MEMORANDUM

From:	Tina Cuss Ecology Officer		
Service	WBC Ecology	App No:	242015
Address:	349 Hyde End Road, Spencers Wood, Wokingham, RG7 1DD.		
Proposal:	Householder application for the proposed reconfiguring of the main roof from hipped to end gable, first floor and second floor extensions, including the addition of dormer windows and roof lights.		
Type of Development:	Other Householder		
Site Visit Made:	No

n. External target note	n. Internal target note	 Chimney	 Roof void
Drawn by: JM	Date: October 2024	Scale: Not to scale	349 Hyde End Road, Spencers Wood Preliminary Roost Assessment Plan

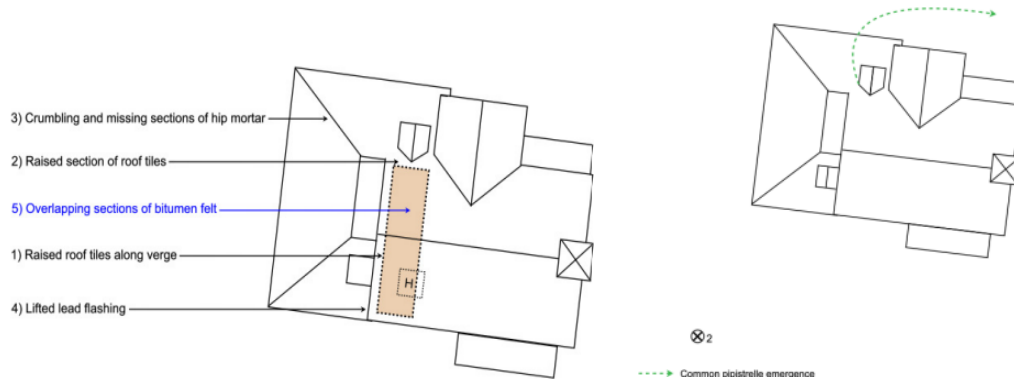
The external surveys identified the following potential bat access points and roost features:

- Lifted roof tiles along the western verge of the house on the front, behind the front dormer window, and rear elevation,
- Crumbling and missing sections of hip mortar on the western section of the roof; &
- Overlapping sections of bitumen felt within the void.

According to the ecologist these features offer potential crevice roosting features for

a small number of crevice-dwelling bats such as common and Soprano pipistrelle. I support the conclusion that the property is considered to be of moderate suitability for roosting bats.

FIRST FLOOR PLAN As Proposed
Scale 1:50

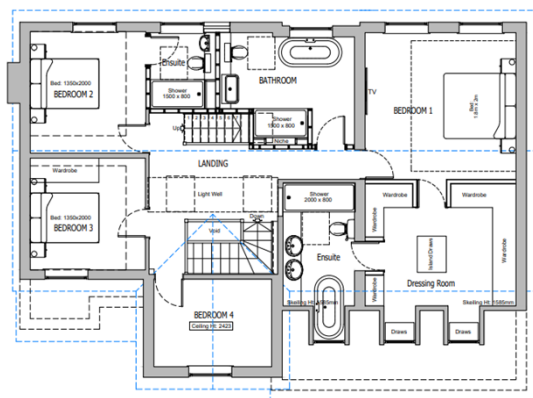
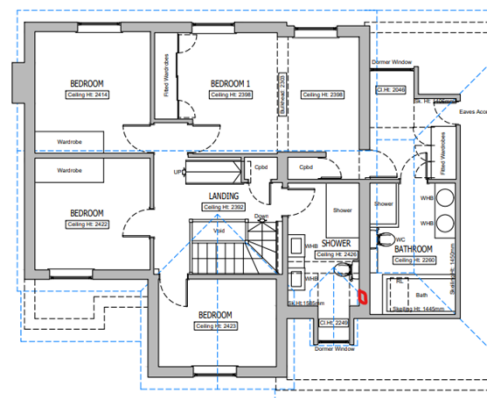
I consider that the survey effort and methodology are adequate. I support the conclusion that the house supports a day roost for an individual Common pipistrelle. I am not satisfied that the Ecologist has fully taken into account the location of the external wall and the roof covering that would have to be removed to install timbers for the extension roof.

Paragraph 6.2.1 states that the alterations to the existing roof and proposed second storey extension “*are highly unlikely to result in the damage or destruction of the confirmed bat roost, as the existing former window and hanging tile cladding is to be retained and will be available during construction and in the long term*”. The application form and elevation drawings do not confirm if the existing front dormer window would be replaced. I am concerned that the number of lifted tiles in the construction design of the existing roof will result in dismantling of more of the roof than has been considered by the Ecologist. The Ecologist fails to consider the impact of increased light pollution, including from the new dormer windows on the bat roost. According to the Good Practice Guidelines “*Current lighting levels and location should be noted to provide a comparison with new lighting proposals*”. However, the exterior lighting as well as light pollution impacts have not been recorded, and no mitigation or enhancements have been recommended by the Ecologist in line with policy and best practice.

If the application is approved, implementation of the development in strict accordance with the Precautionary Working Method Statement must be secured by condition in order to minimize the risk and avoid illegal disturbance of the confirmed roost in the dormer. Consideration must be given to direct ecological supervision of the roof stripping works set out in BES Section 6.3.2. If the dormer window is not retained and any hanging tile will be disturbed, a revised Precautionary Working Method Statement and details of proposed replacement roosting features must be submitted to, and approved by the LPA.

Provided that the dormer structure, existing window hanging tiles and cladding are not affected and the removal of minimal areas of roofing tiles will be affected the development can be implemented legally under a non-licensed precautionary method statement secured by planning condition.
